DEPARTMENT OF THE ARMY
US ARMY CHEMICAL SCHOOL
401 ENGINEER LOOP
FORT LEONARD WOOD, MISSOURI 65473-8926

The additional information you requested in your letter dated March 1, 2000 concerning the groundwater assessment of the Pelham Range site is attached.

**RESPONSE TO REQUEST FOR ADDITIONAL INFORMATION CONCERNING
RADIOACTIVE MATERIALS LICENSE AMENDMENT REQUEST
DATED MARCH 2, 1999**

**Rideout
Field
Geology**

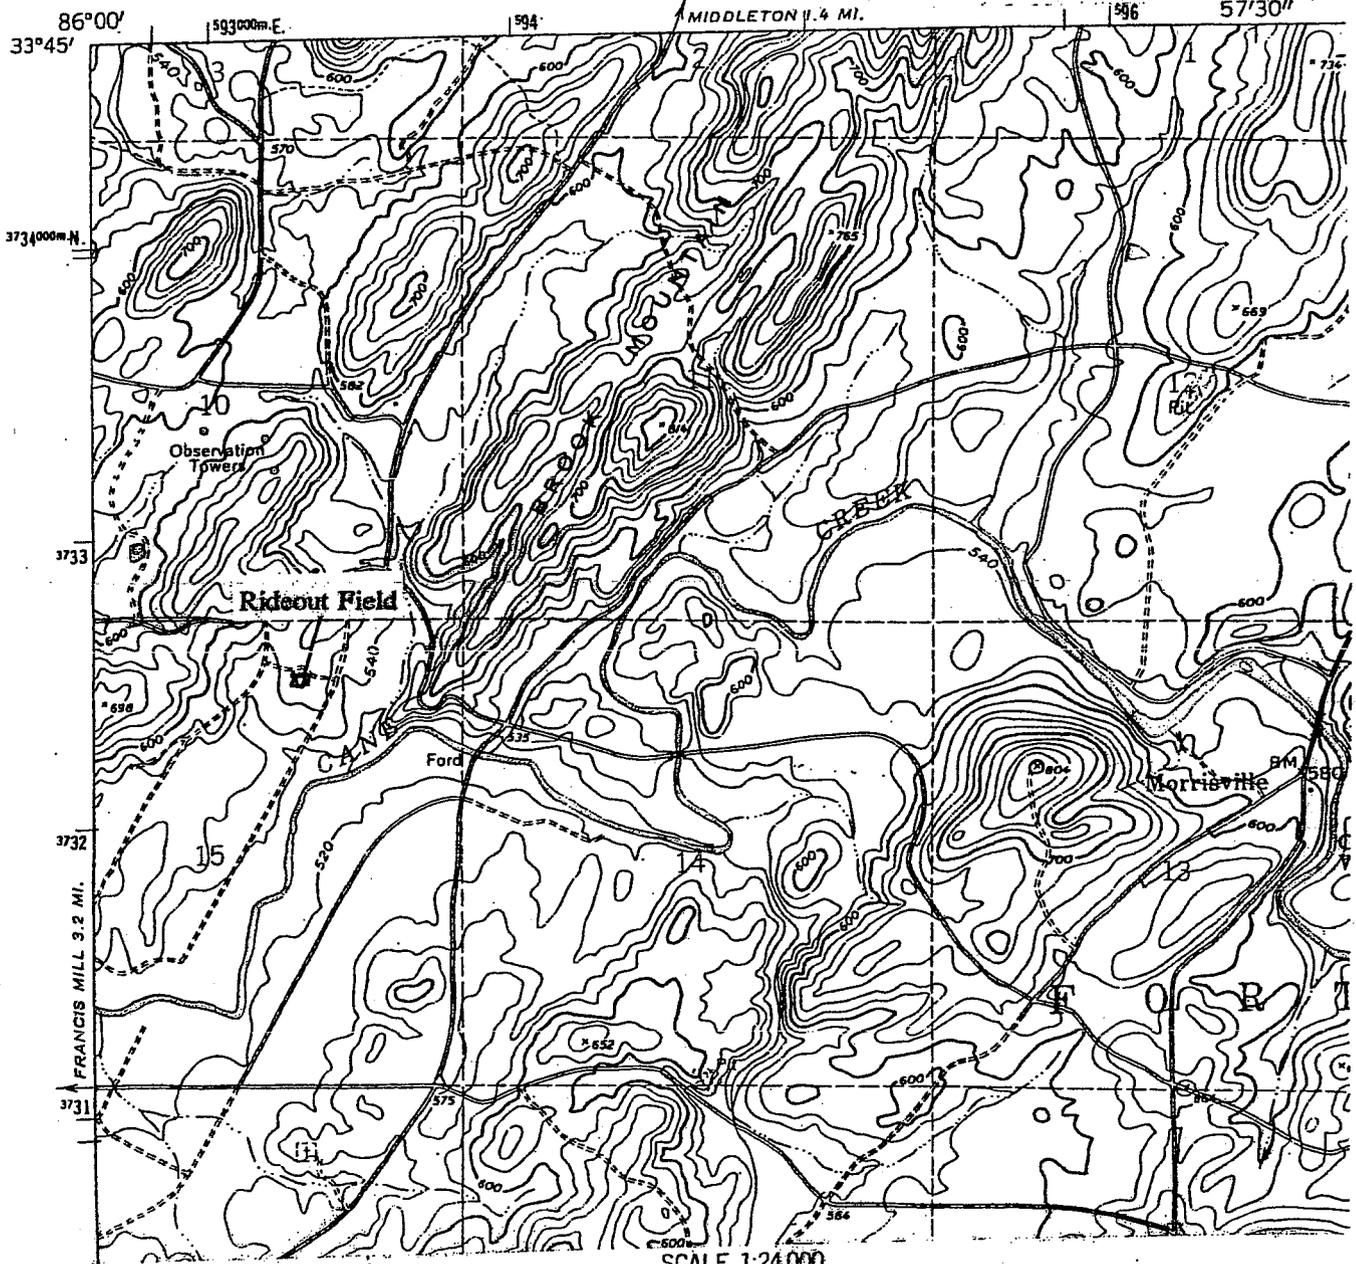
Comment 4: **Existing hydrogeologic data for this area should be compiled and examined. This would include a topographic map of the site, which can be used to delineate surface water drainage and to estimate water table elevations for perennial surface water features.**

Response: There is not any historic hydrogeologic information that has been collected for this area. During installation of planned monitoring wells, hydrogeologic data will be collected for this area. A topographic map is attached to show surface water drainage. Water table elevations and the direction of groundwater flow will be defined with the well installation program.
